RE: Project: PR-2022-007565; SP2025-00075- SITE PLAN DFT Comment responses

To whom it may concern,
I am in receipt of comments provided on 10/22/2025 and have provided the following revisions, and responses to those comments:

A2 TYPICAL SITE WALL DETAIL
1/2"=1'-0"

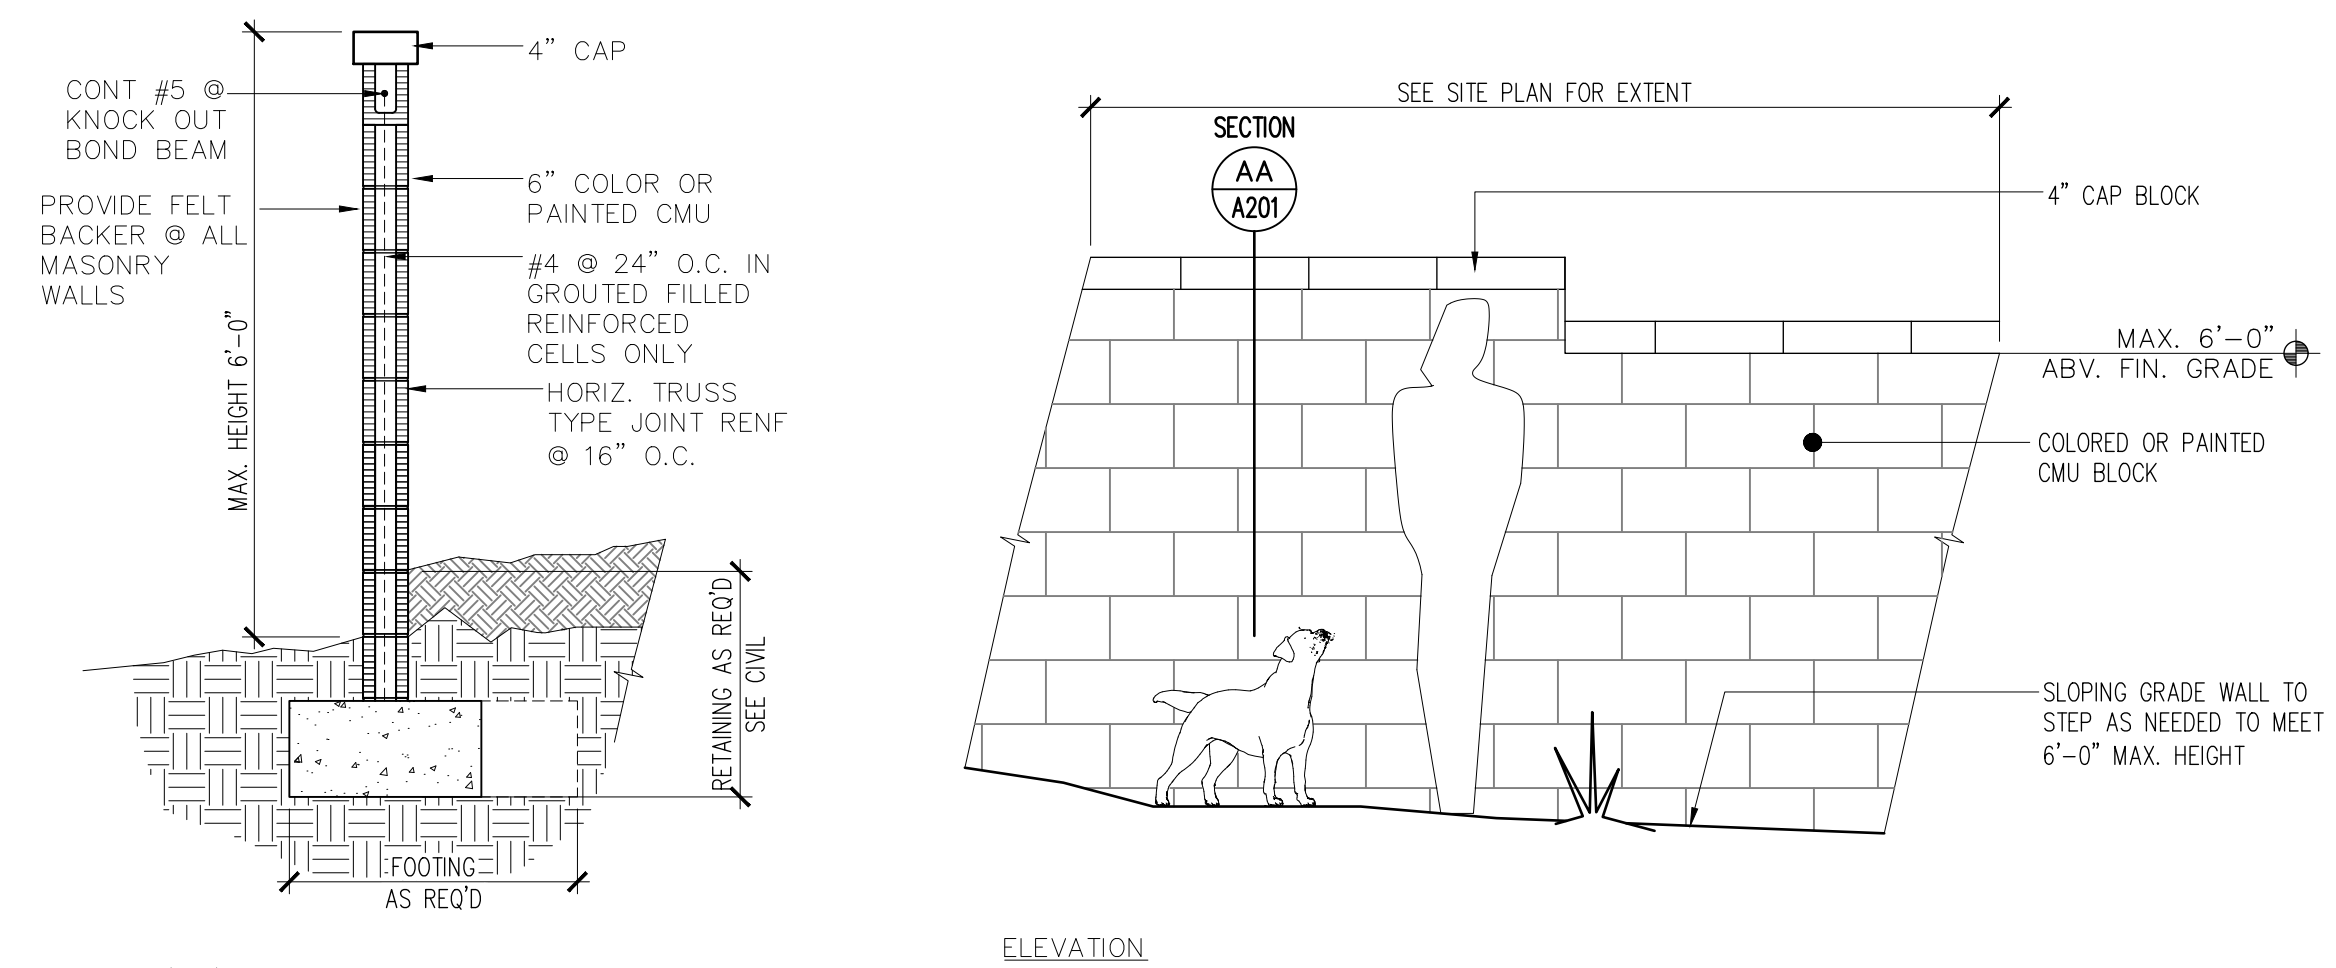
1. Add a detail to the elevations sheet showing the proposed 6' opaque fence shown as keyed note #6 on the site plan.

Response: Detail showing proposed material and construction of the opaque fence has been added to sheet A201.

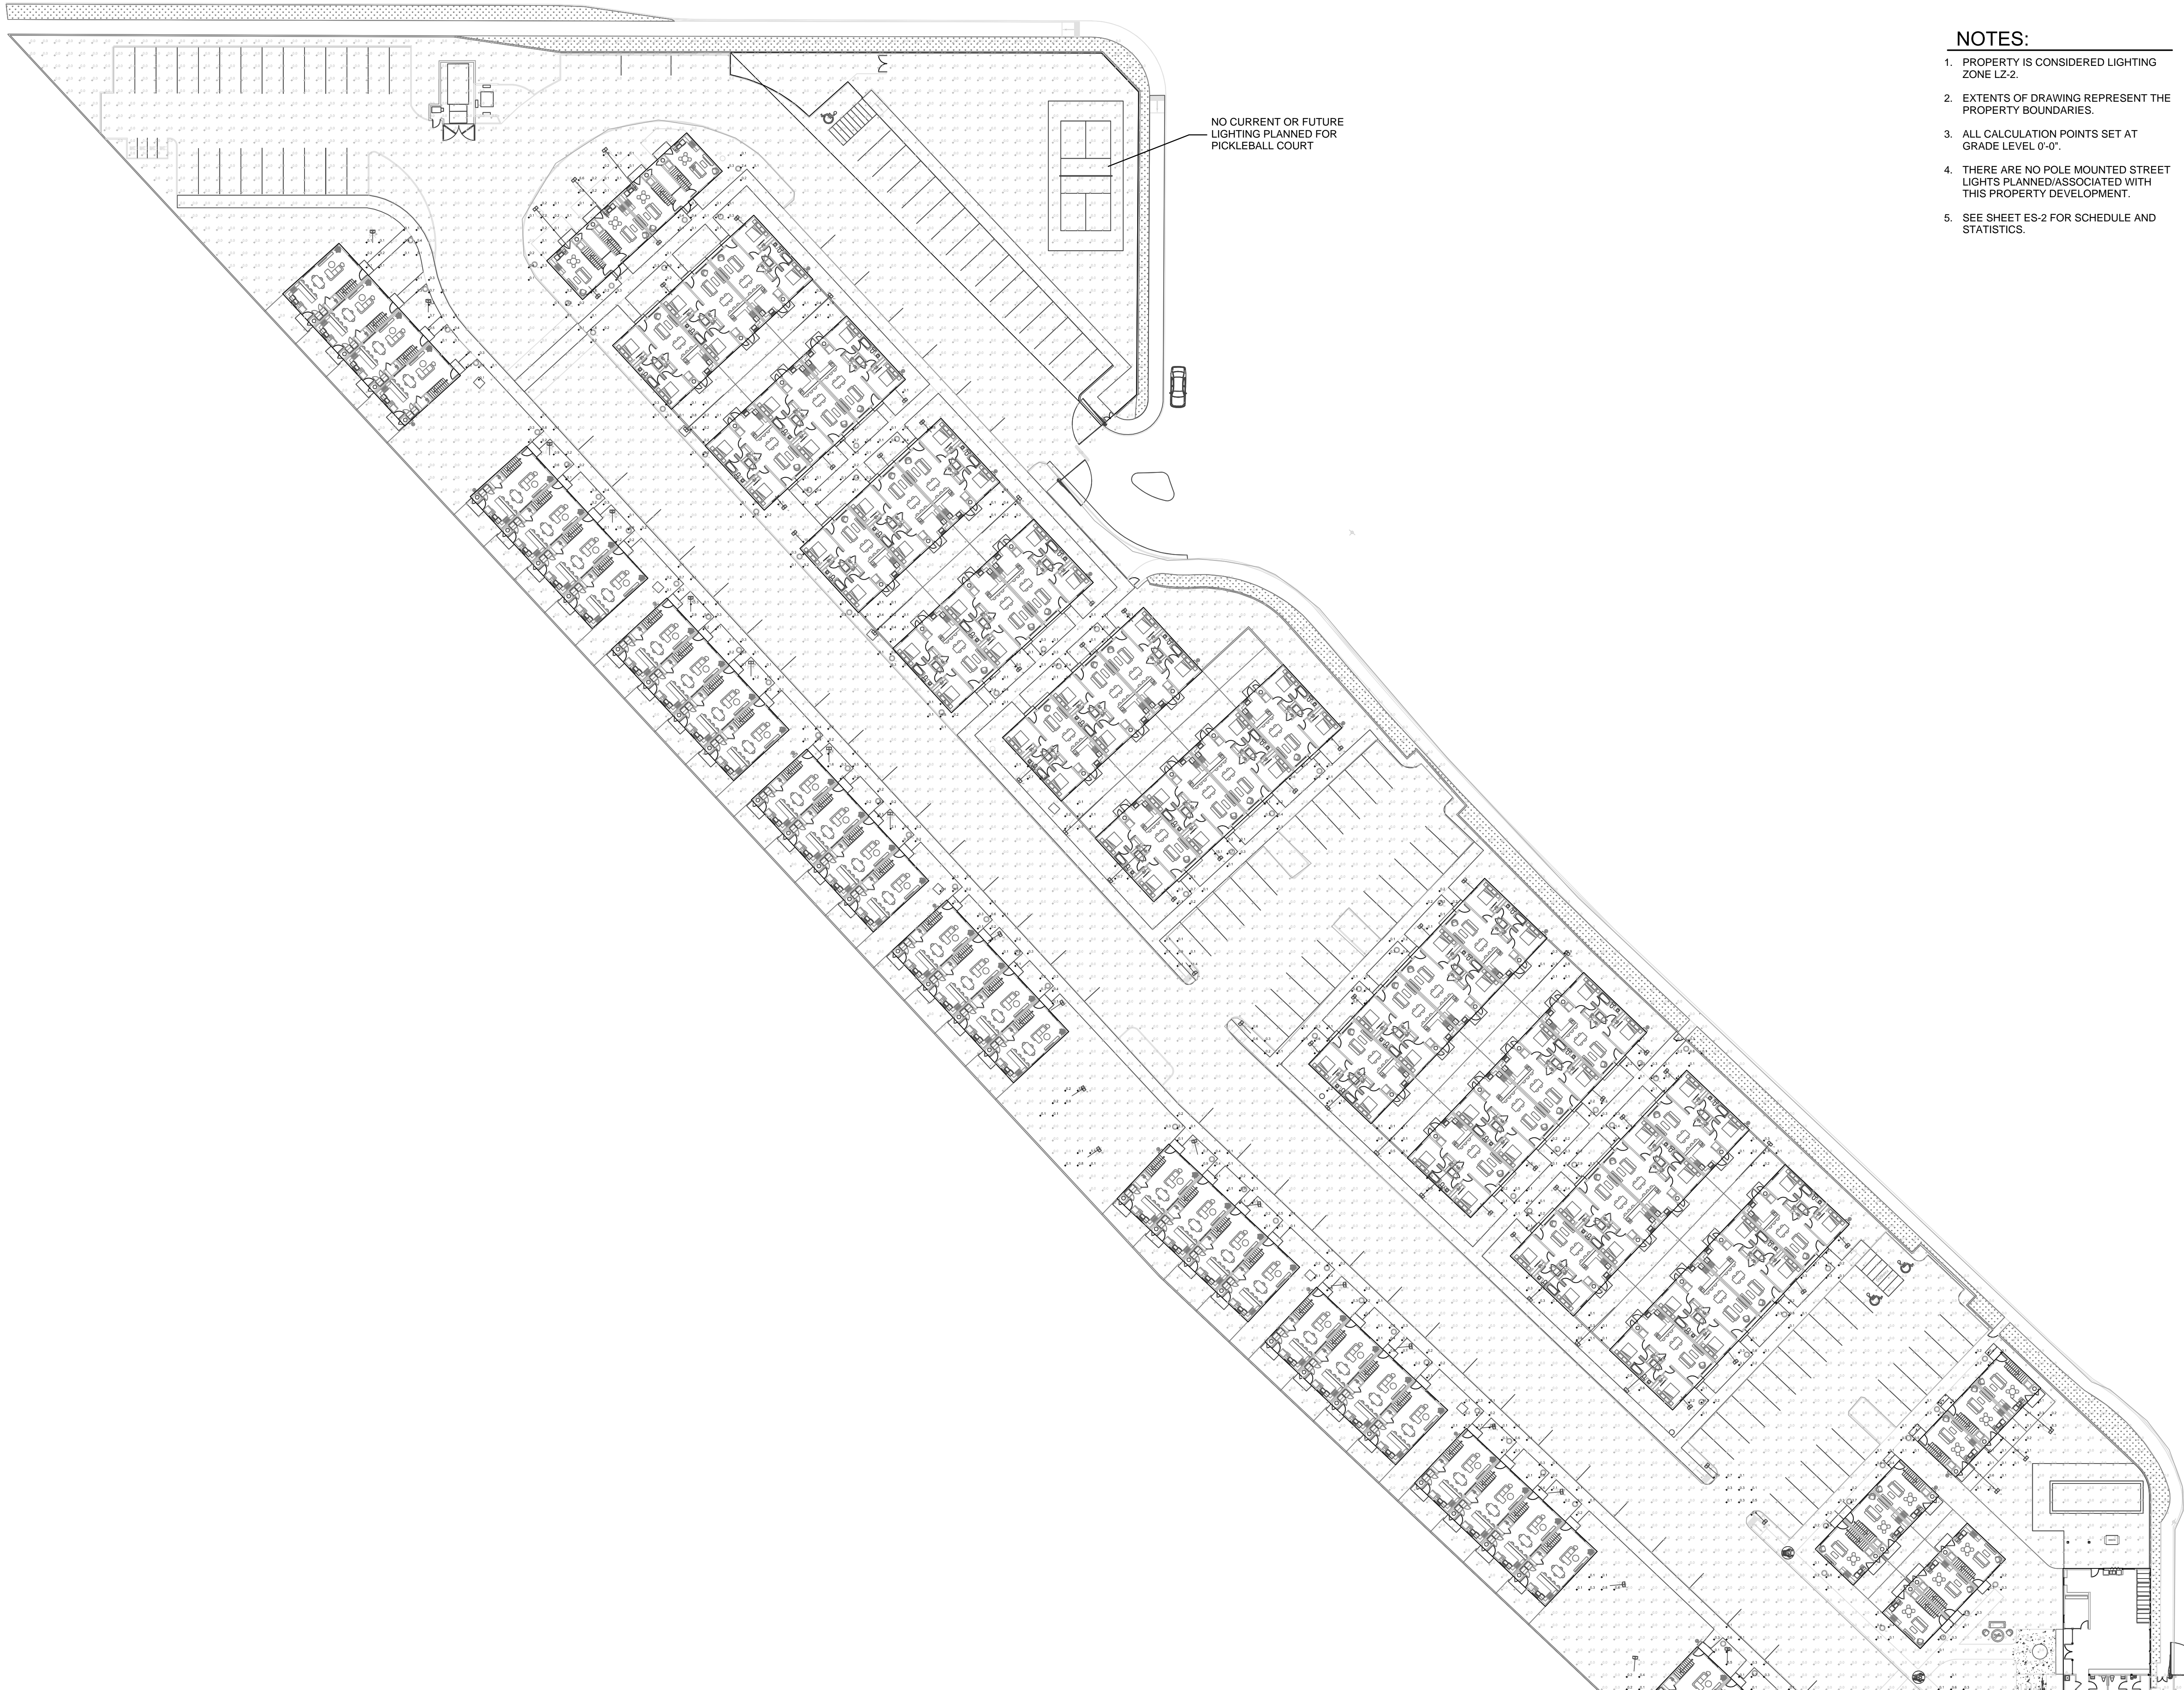
4. Lighting: Designation for Zone District, IDO 5-8(F): Must show compliance with standards:
 - a. Lighting Designation, IDO 5-8(F), Table 5-8-2. Property is designated an LZ-2 light zone.

Response: A lighting sheet has been added to the set. This designation has been included in the notes.
 - b. Light Trespass, IDO 5-8(F)(4), Table 5-8-3: Provide photometric site plan showing how total illumination (from interior and exterior light sources) complies with light trespass requirements at the property line for the LZ-2 light zone.

Response: A photometric site plan has been added to the set which illustrates compliance.
5. Lighting: Total Lumen Allowance, IDO 5-8(G): Provide documentation of compliance with Total Lumen Allowance and Total Lumens allowed per dwelling, IDO Table 5-8-4.

- NOTES:**
1. PROPERTY IS CONSIDERED LIGHTING ZONE LZ-2.
 2. EXTENTS OF DRAWING REPRESENT THE PROPERTY BOUNDARIES.
 3. ALL CALCULATION POINTS SET AT GRADE LEVEL 0'-0".
 4. THERE ARE NO POLE MOUNTED STREET LIGHTS PLANNED/ASSOCIATED WITH THIS PROPERTY DEVELOPMENT.
 5. SEE SHEET ES-2 FOR SCHEDULE AND STATISTICS.
